LANDSIDE ACCESS MODERNIZATION PROGRAM

ITF-W_A Interim Ground Access (IGA) **Project # DA-5305A**

Package Transmitted For	Delivered Via	Tracking Number
CO-0008-PDG FULLY EXECUTED ITF-W A Interim Ground Access (IGA) Change Order #08 for CPCN No# 1007A, 1004A, 1003A, and 1011A 2019-06-21		CO-0008-PDG FULLY EXCUTED

CHANGE ORDER NO. 0008

SHEET C101
SCALE AS NOTED
DATE 03 / 28 / 2019
DWG NO. 20180516
FILE NAME C100.DWG

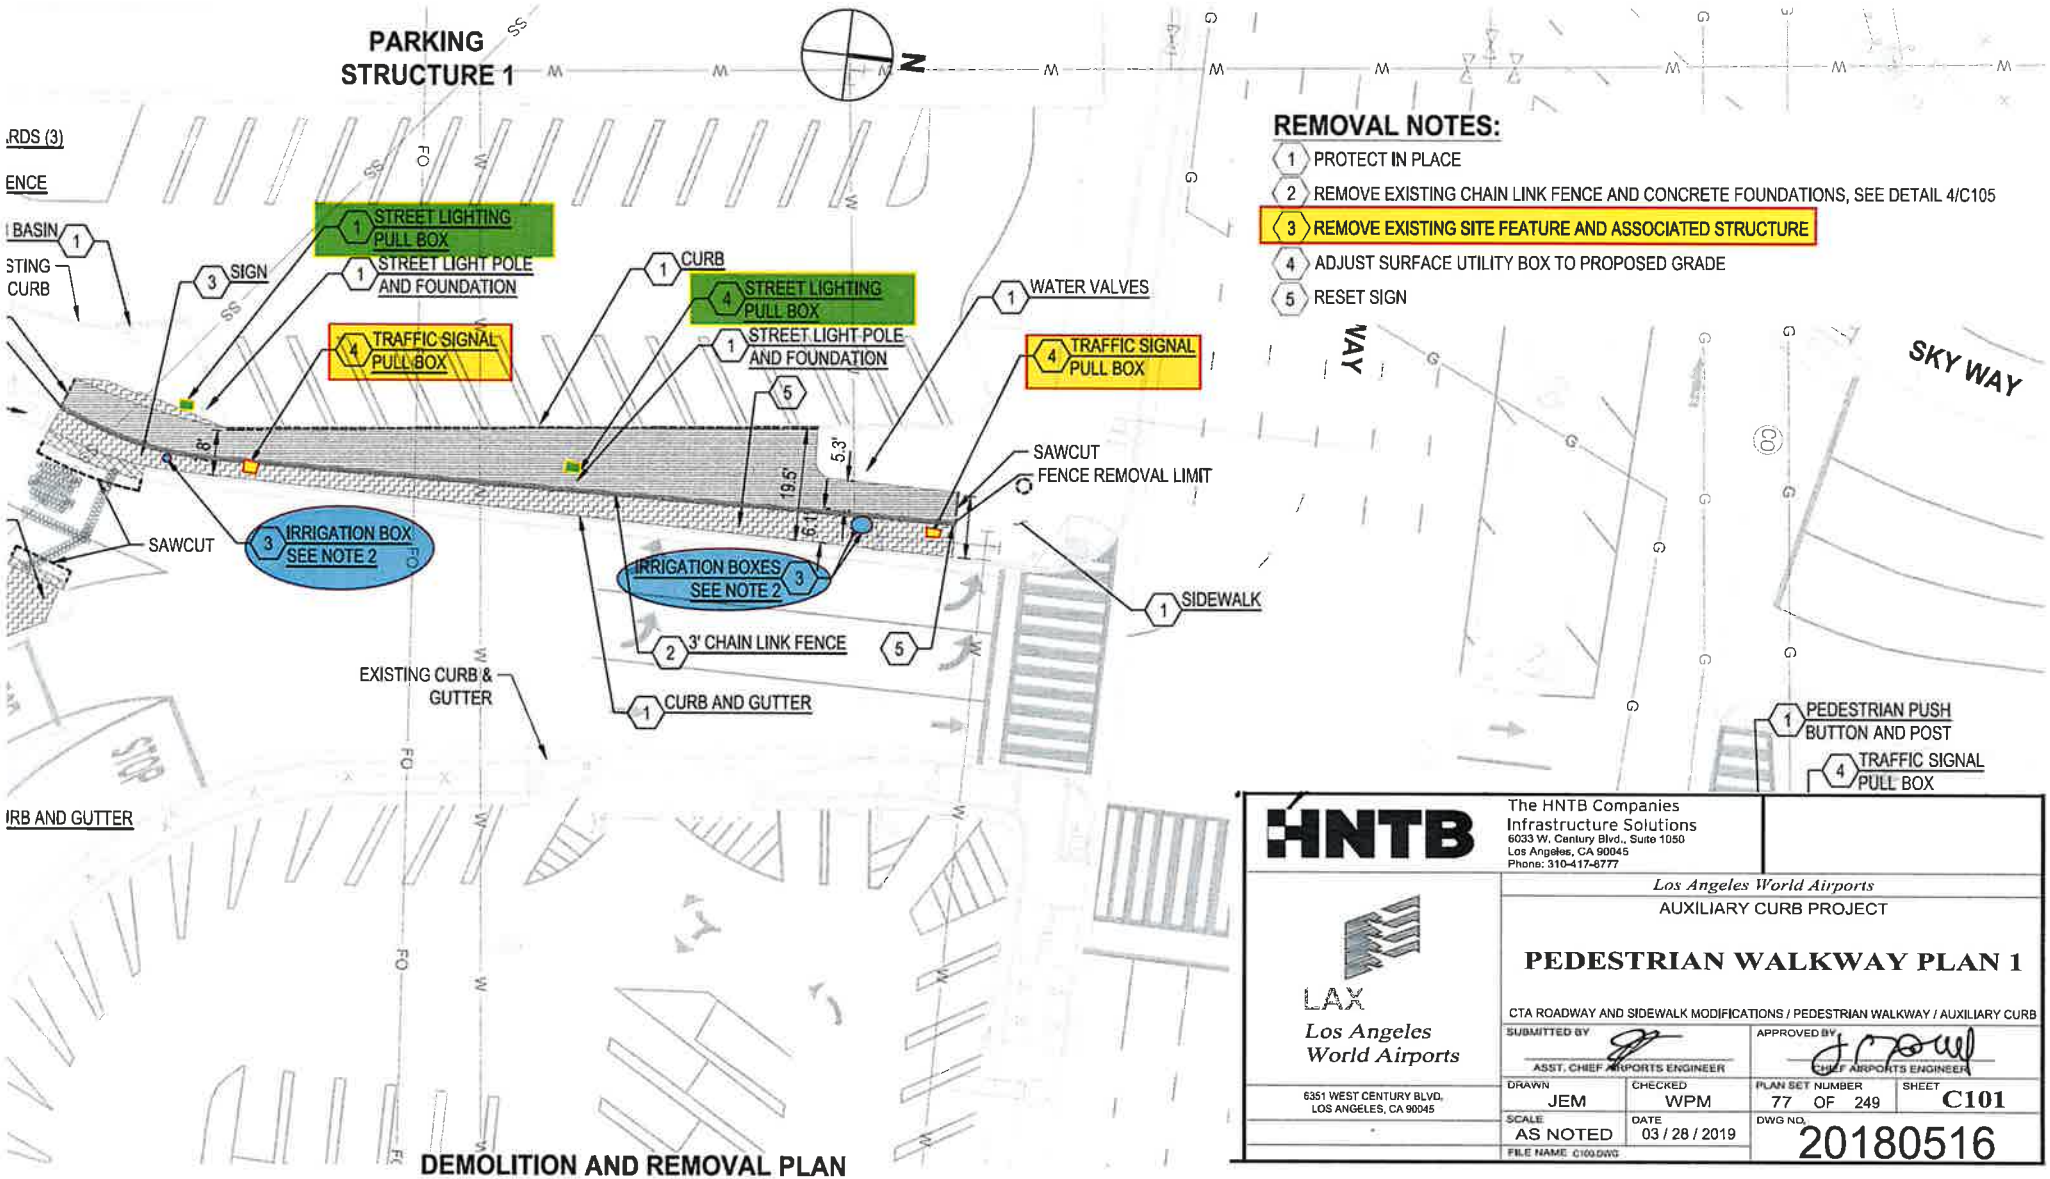
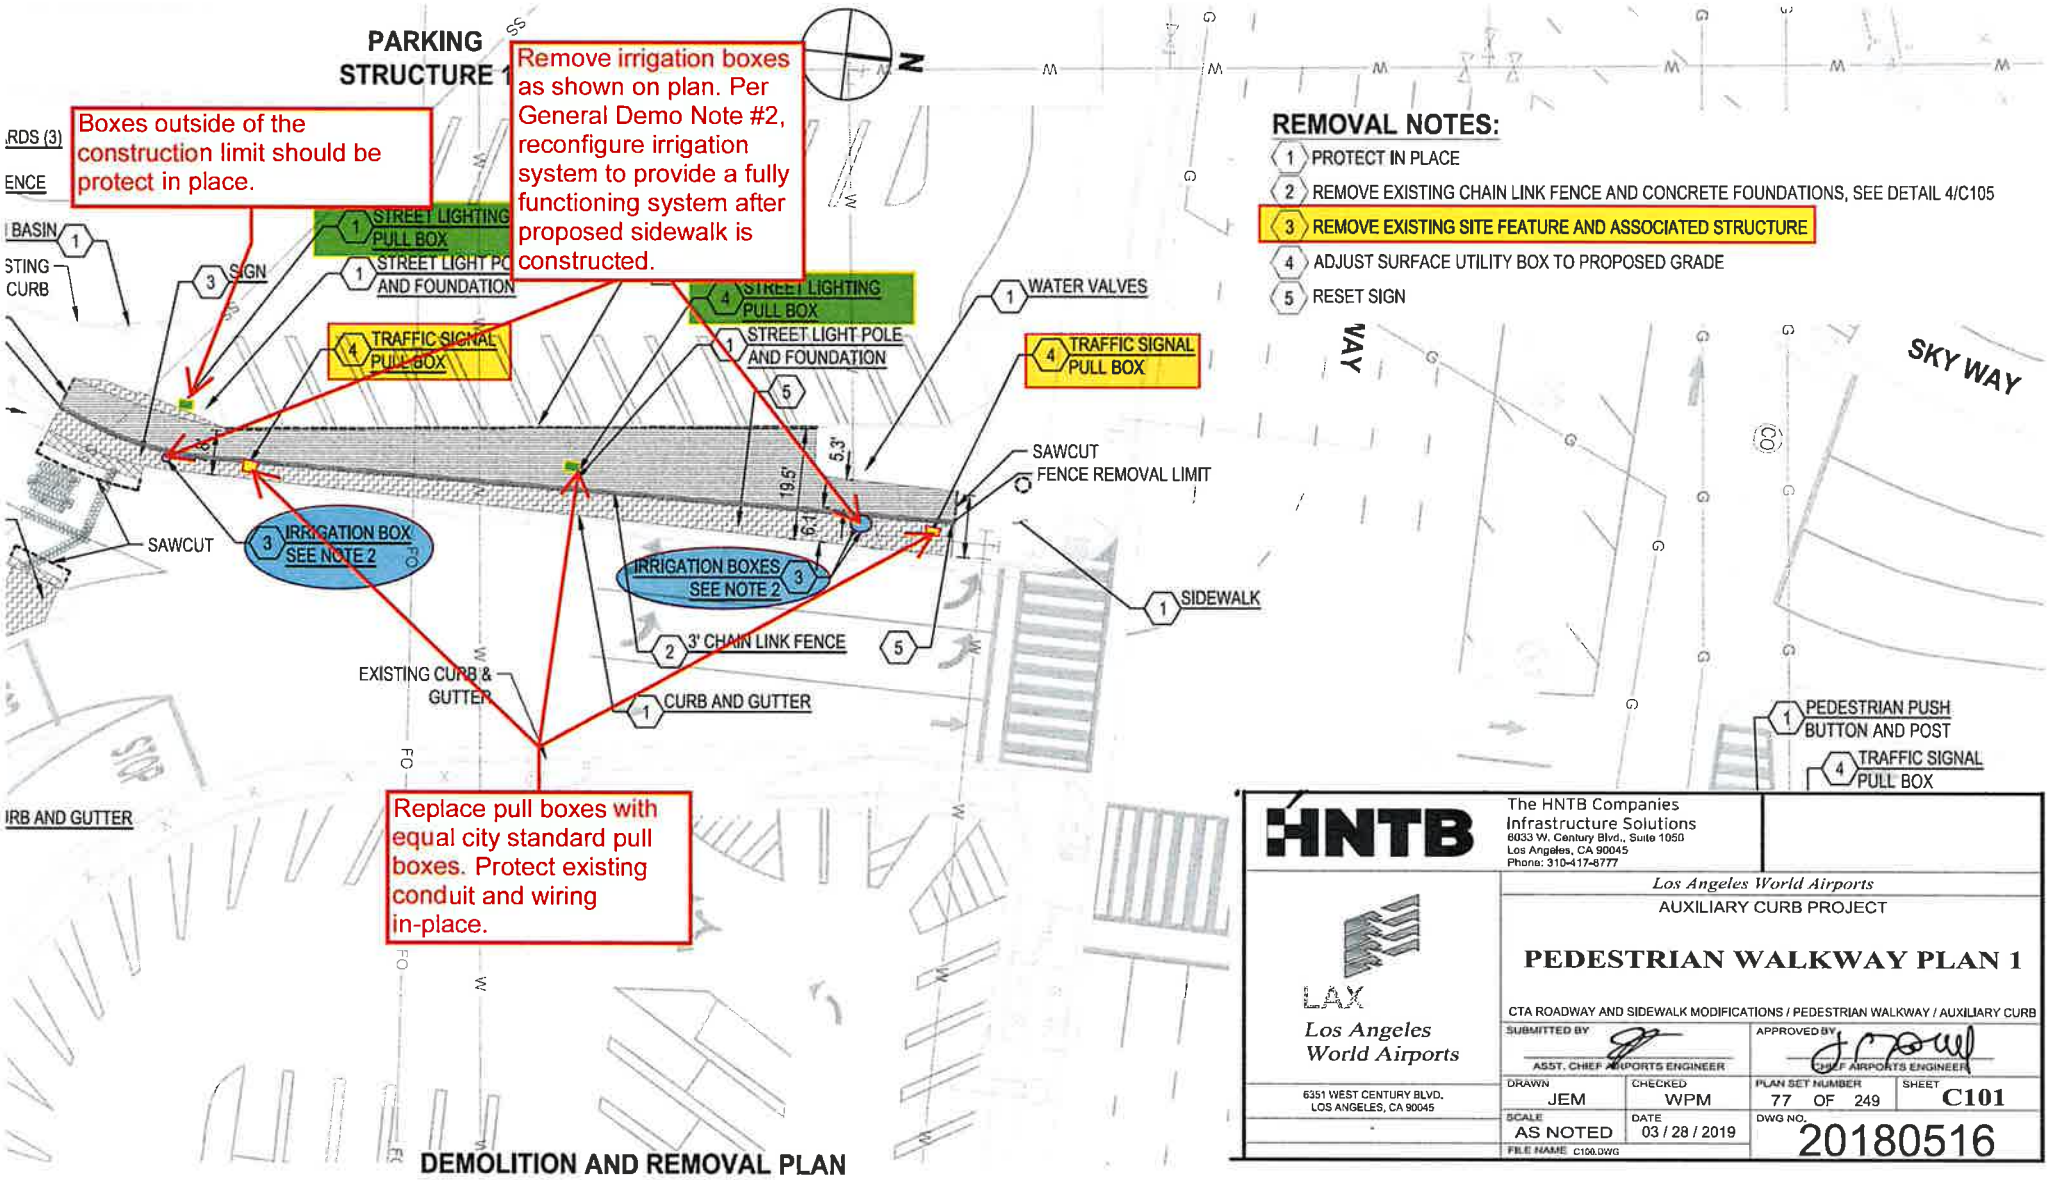
[4/10/2019 Swinerton Builders - Etezazian, Ata]
Reference Sheet: C101 (attached)
Per sheet C101 Removal Notes, some existing utility boxes are to be removed, some are to be protected in place, and others are to be adjusted to proposed grade. As shown in attached document, many boxes are damaged and further damage can occur during demo/relocation. Please advise if damaged boxes are to remain and be re-used or should they be replaced with new boxes? (new boxes will be added cost to LAWA)

PARKING STRUCTURE 1
Boxes outside of the construction limit should be protect in place.
Remove irrigation boxes as shown on plan. Per General Demo Note #2, reconfigure irrigation system to provide a fully functioning system after proposed sidewalk is constructed.
Replace pull boxes with equal city standard pull boxes. Protect existing conduit and wiring in-place.
STREET LIGHTING PULL BOX
STREET LIGHT POLE AND FOUNDATION
TRAFFIC SIGNAL PULL BOX
SIGN
IRRIGATION BOX SEE NOTE 2
IRRIGATION BOXES SEE NOTE 2
SAWCUT
EXISTING CURB & GUTTER
CURB AND GUTTER
3' CHAIN LINK FENCE
WATER VALVES
SAWCUT
FENCE REMOVAL LIMIT
SIDEWALK
PEDESTRIAN PUSH BUTTON AND POST
TRAFFIC SIGNAL PULL BOX
SKY WAY
REMOVAL NOTES:
1 PROTECT IN PLACE
2 REMOVE EXISTING CHAIN LINK FENCE AND CONCRETE FOUNDATIONS, SEE DETAIL 4/C105
3 REMOVE EXISTING SITE FEATURE AND ASSOCIATED STRUCTURE
4 ADJUST SURFACE UTILITY BOX TO PROPOSED GRADE
5 RESET SIGN
DEMOLITION AND REMOVAL PLAN

Contractor shall provide labor, materials and equipment required to replace the existing damaged utility boxes as directed in the response to RFI-0010. CD-0007 was issued on 04/30/2019 directing Swinerton to proceed with removing the existing utility boxes shown on drawing C101 and replace with new boxes. Boxes outside of the construction limit should be protect in place. The Costs associated with T&M authorization shall fully comply with General Conditions by (T&M).

Added cost to replace damaged utility boxes per RFI 00010 and sheet C101.
